ORDINANCE NO. 1913-19

AN ORDINANCE AUTHORIZING THE EXECUTION OF THE VILLAS AT THE COMMONS SUBDIVISION IMPROVEMENT AGREEMENT – K. HOVNANIAN T & C HOMES AT ILLINOIS LLC

**THE VILLAS AT THE COMMONS SUBDIVISION – PLANNED UNIT
DEVELOPMENT PLAN AND PLAT & OTHER RELATED PLANS – SUBSTANTIAL
CONFORMITY CERTIFICATION**

SALES OFFICE PLAN

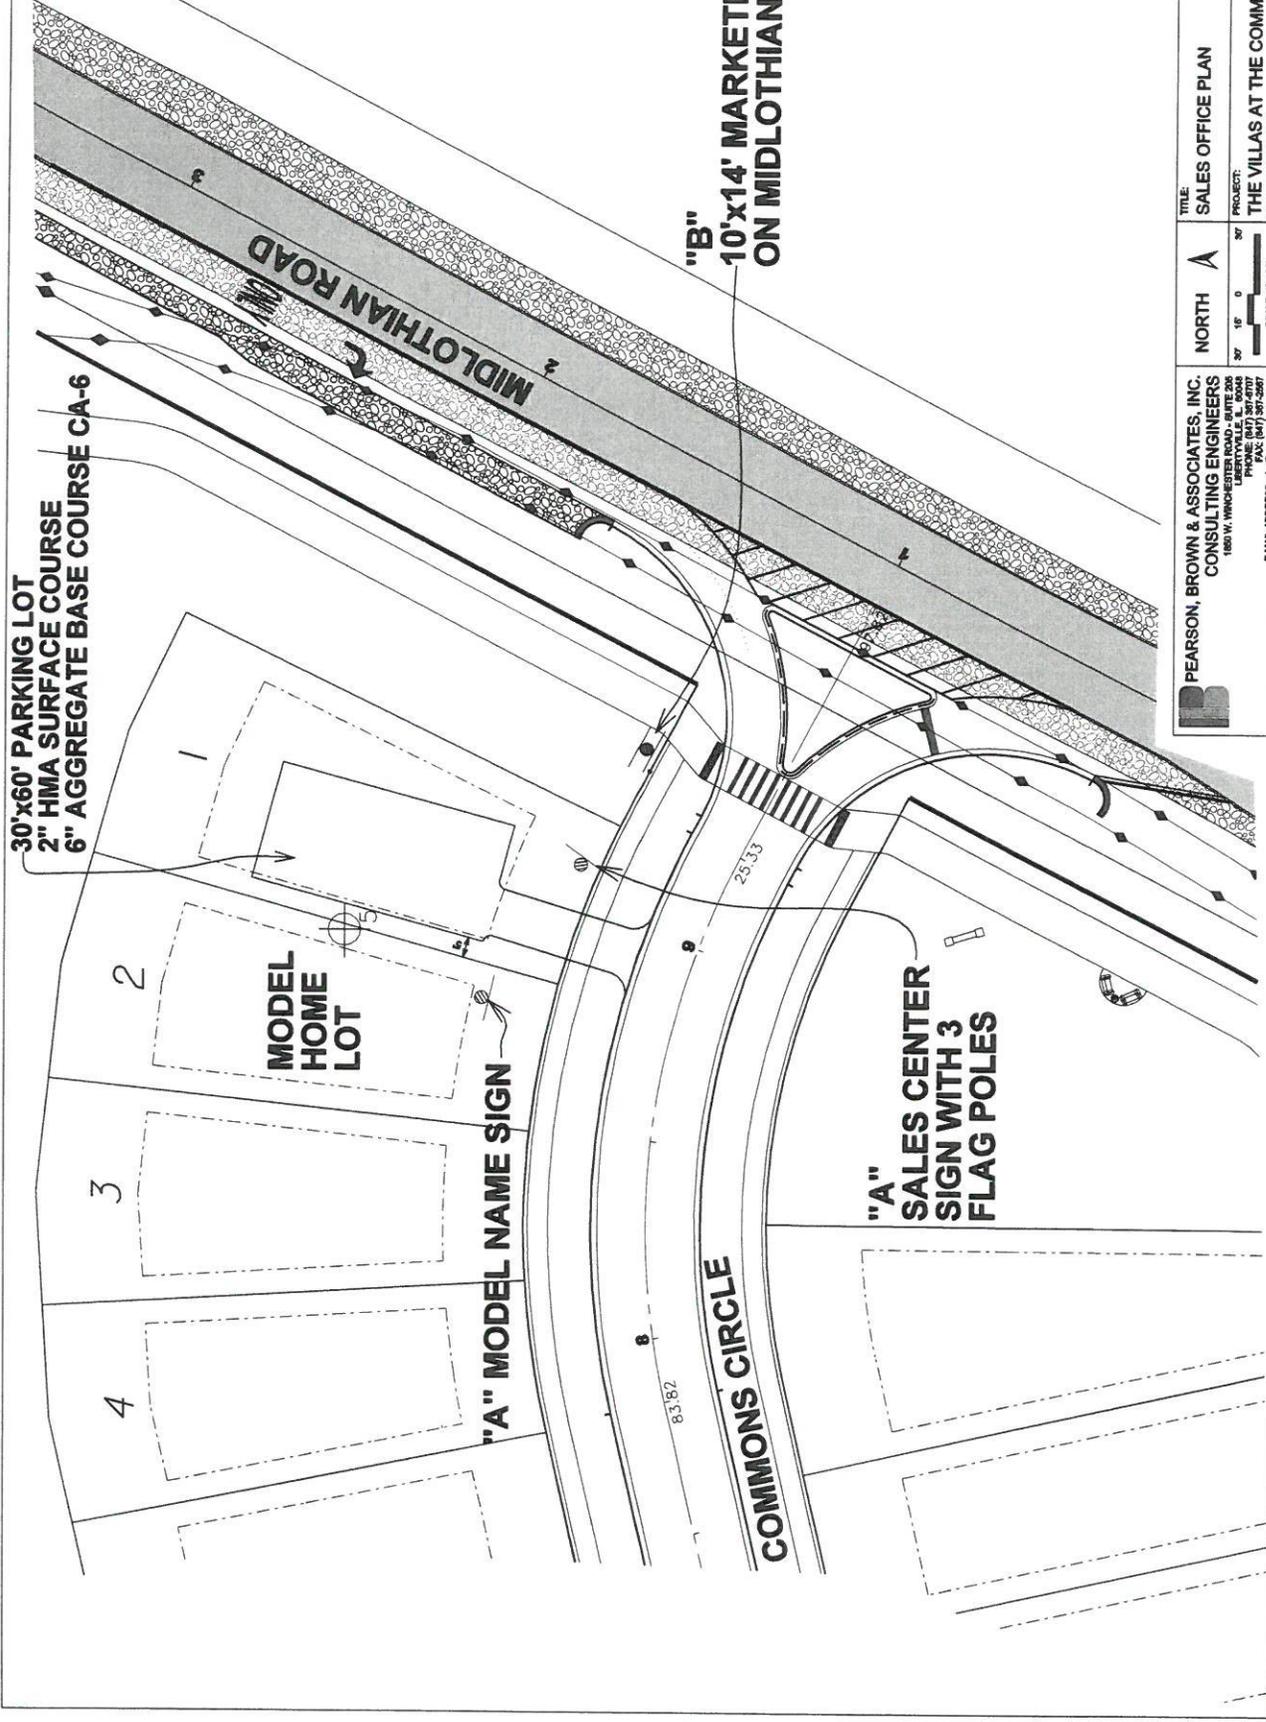
subdivision ordinance. We will pave the parking lot and provide you with a specification detail for your approval. Since this is a temporary lot, there is no need to design it to meet street specifications.

EXHIBIT J
FINAL LANDSCAPE PLAN

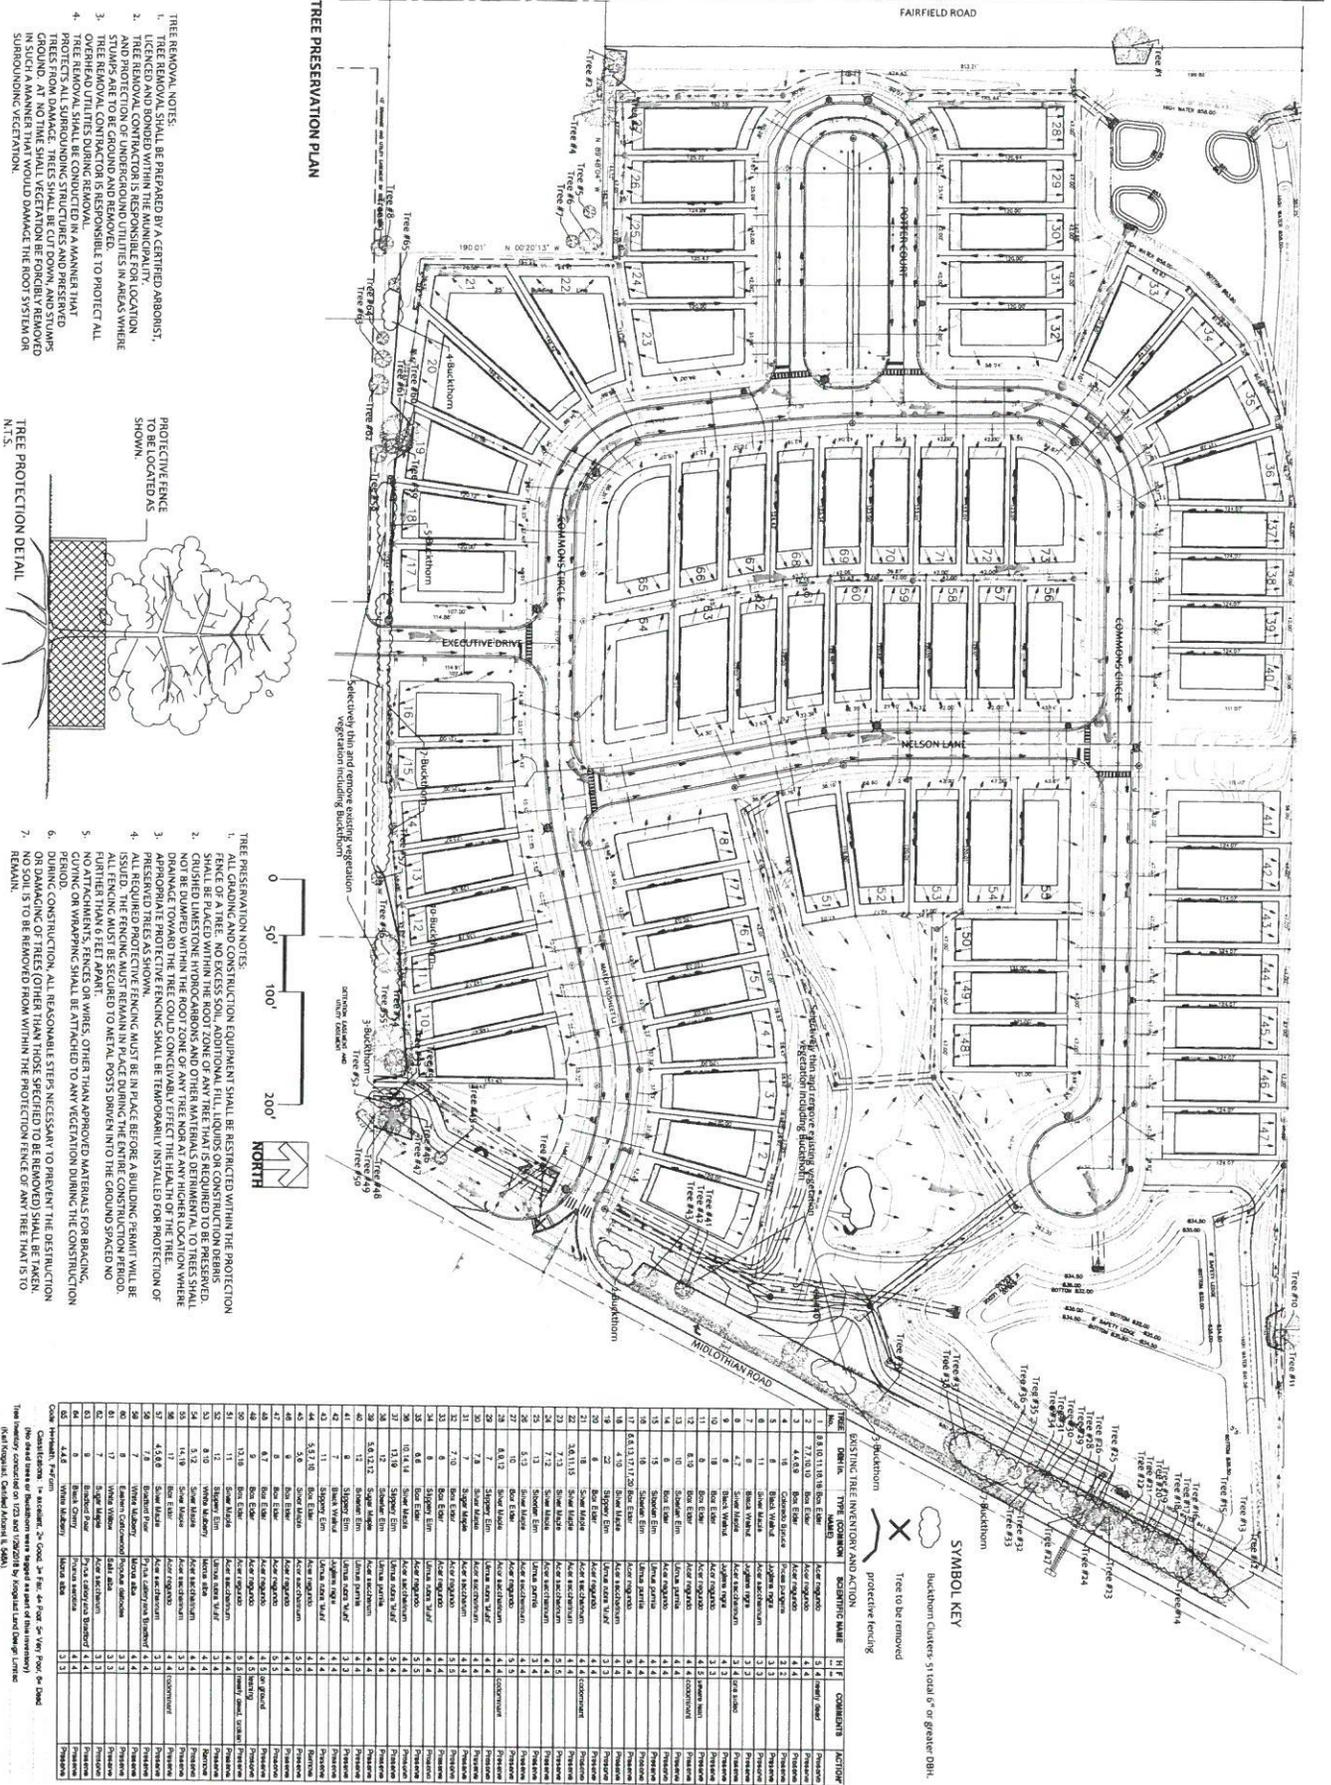
1. Provide quantity and cost for the following: Trees, shrubs, benches, overlook, trash receptacles, monument sign and playground equipment. This will be provided with the revised plans.

1. **Comment:** The monument sign is proposed within a drainage easement. It must be moved outside of easements and not in the Village right-of-way. **Response:** The monument shall be located outside of easements on the next submittal.
2. **Comment:** Most trees proposed along the street are located on individual lots and not in the right-of-way. **Response:** Noted

1. **Comment:** Provide quantity and cost for the following: Trees, shrubs, benches, overlook, trash receptacles, monument sign and playground equipment. **Response:** The quantity and cost for the items listed shall be provided as part of the next submittal.

In addition, a comment was made that the monument sign should include the words “of Hawthorn Woods” so that the sign text should read “The Villas at the Common of Hawthorn Woods”.

- 4.c. **Response:** Hatching for the different types of proposed seeding shall be identified in a legend on the next submittal. Seeding information, including rates, species etc., has been provided to the project civil engineer to be included on the Erosion Control Plan.

1. **Response:** The Playground detail shall be added to the landscape plan on the next submittal.
2. **Response:** Two overstory shade trees shall be added in the gathering area along the Midlothian Road trail.
3. **Response:** There are currently 2 benches proposed at the playground. An overstory shade tree shall be added behind the benches.
4. **Response:** Border timbers for the playground shall be a non-wood material. The playground colors shall be tan and green. These items shall be specified on the next submittal.
